Addendum 52 – UN Regulation No. 53

Revision 3 – Amendment 7

Supplement 20 to 01 series of amendments – Date of entry into force: 15 October 2019

Installation of lighting and light-signalling devices for L₃ vehicles

"Annex 7

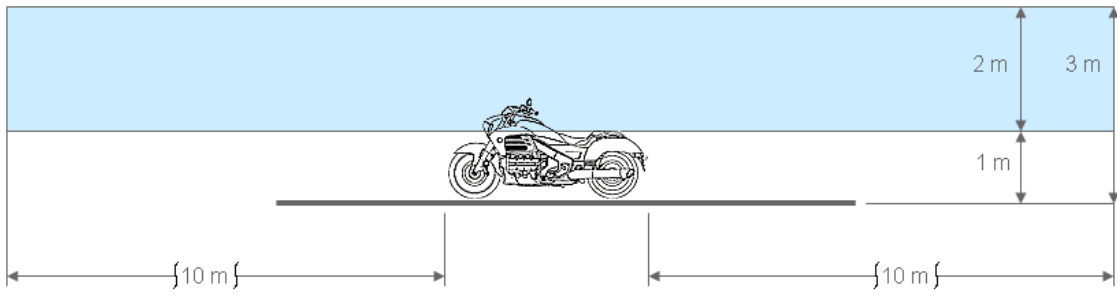
- 6.15.9.3. The technical service shall, to the satisfaction of the Type Approval Authority, perform a visual test to verify that there is no direct visibility of the apparent surface of the exterior courtesy lamps, if viewed by an observer moving on the boundary of a zone on a transverse plane 10 m from the front of the vehicle, a transverse plane 10 m from the rear of the vehicle, and two longitudinal planes 10 m from each side of the vehicle; these four planes to extend from 1 m to 3 m above and perpendicular to the ground as shown in Annex 7.

Insert a new Annex 7, to read:

Observing area towards the apparent surface of exterior courtesy lamps

Zones of observation

This drawing shows the zone from one side, the other zones are from the front, the rear and from the other side of the vehicle.
